Technical Bulletin / Safety Alert

Unique ID No: GEN2012-TBSA-01

Subject: VLI Driftrunner & Brumby Start Circuit Modifications – Low Viscosity Fuel

Applicable to: All VLI Driftrunner & Brumby Vehicles

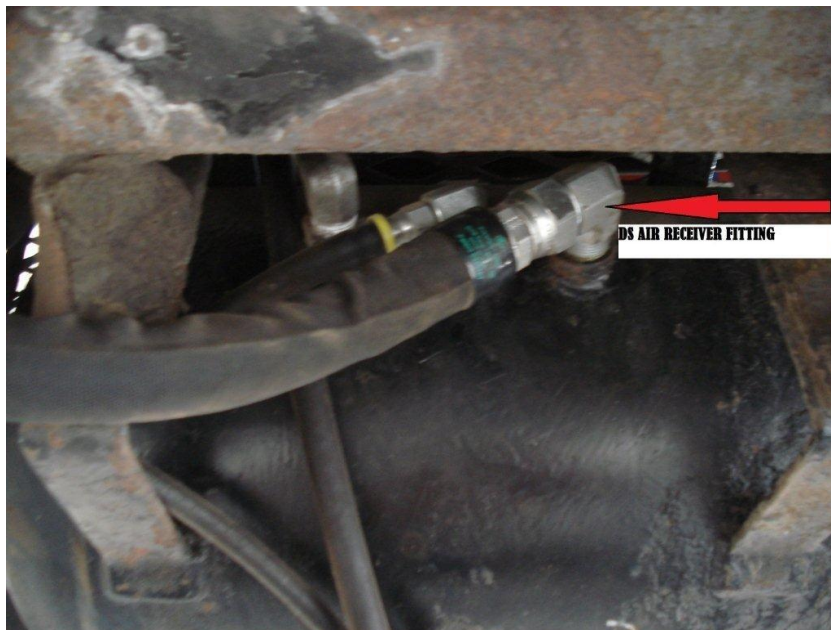
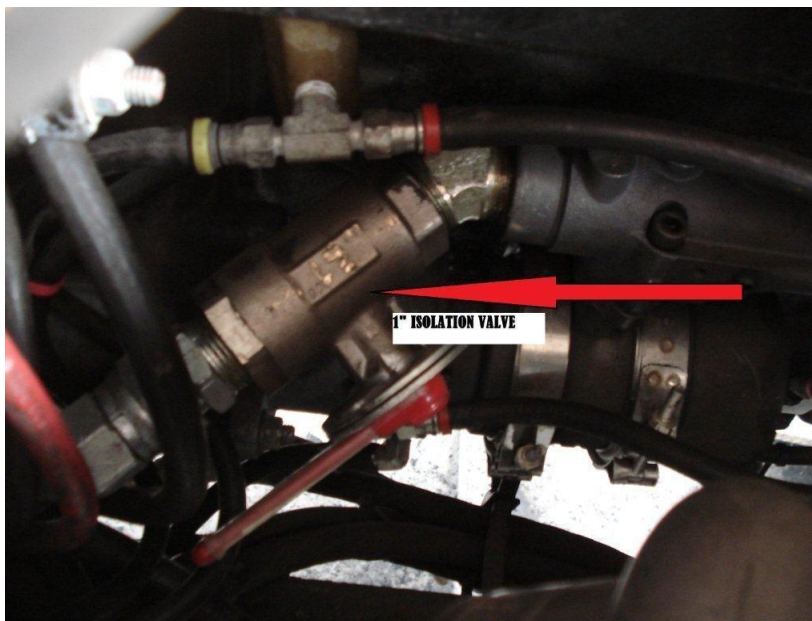
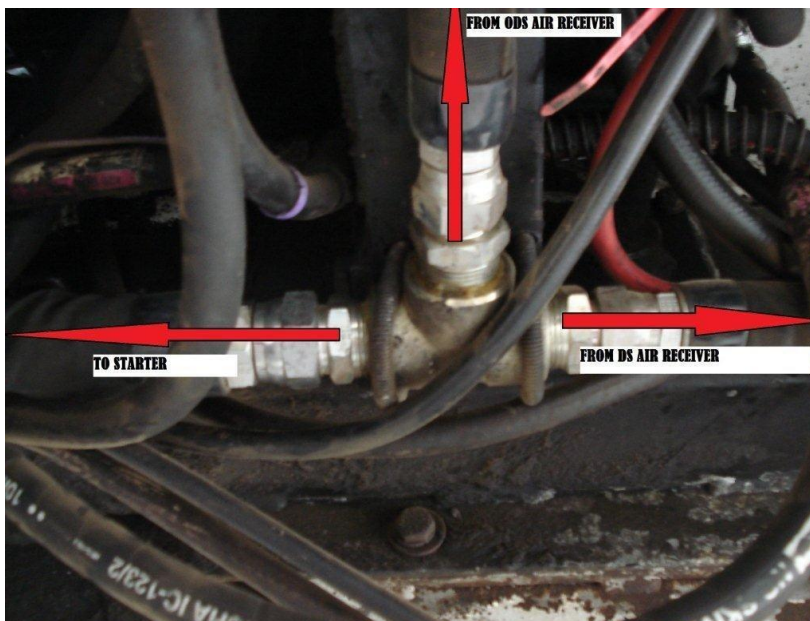
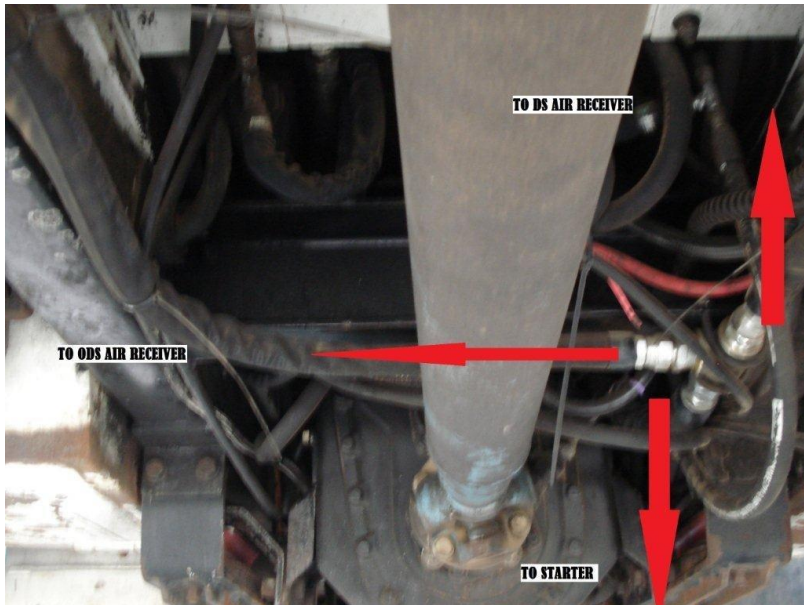
In order to accommodate the use of low viscosity diesel fuels, increased fuel pressure is required at start up. This can be achieved by changing the start circuit from an 'in series' to 'parallel' design, and installing a starter motor with a 12 tooth pinion.

These starter circuit modifications are shown schematically in the attached drawings (5-04168601 & 5-04168701) and in the photos below as installed to a Driftrunner vehicle.

The following parts are required to complete the starter circuit modification:

9-13010061 Starter Motor Assembly – 12 Tooth Pinion

0601-10011 Isolation Valve

9-13010047 50mm, M10, U-BOLTS (2 off required)

And 9-13010046 Hose & Fittings Kit – Starter Motor (Personnel Vehicles)

Or 9-13010100 Hose & Fittings Kit – Starter Motor (Trayback Vehicles)
